2213/2215 REPLACEABLE CABINET FOOT (cont.)

W² Issue 13-2

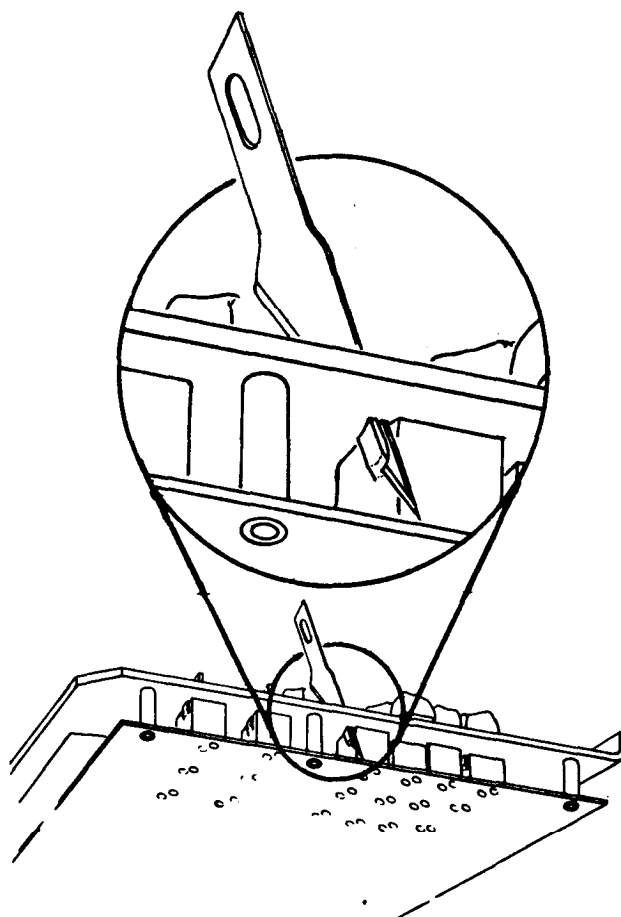
The new part can be installed by placing a hex driver or similar tool into the hole in the foot and pushing the foot into the cabinet. Be sure to support the cabinet so it will not be bent.

4006/4010/402X/405X CHERRY KEYSWITCH REPLACEMENT

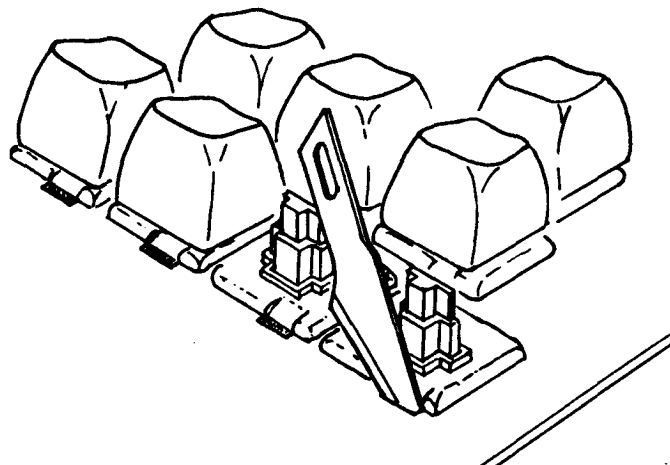
The late style cherry keyswitch, with the expanding mounting tabs, is difficult to remove from the keyboard without first cutting the mounting tabs off.

Older keyswitches have bumps, rather than locking expanding tabs; therefore, do not require cutting.

It has been found that the X-acto blade #11, 002-1040-00, with the long straight edge, works quite well in cutting the cherry keyswitch tabs. Insert blade in keyboard as pictured and cut off tab.
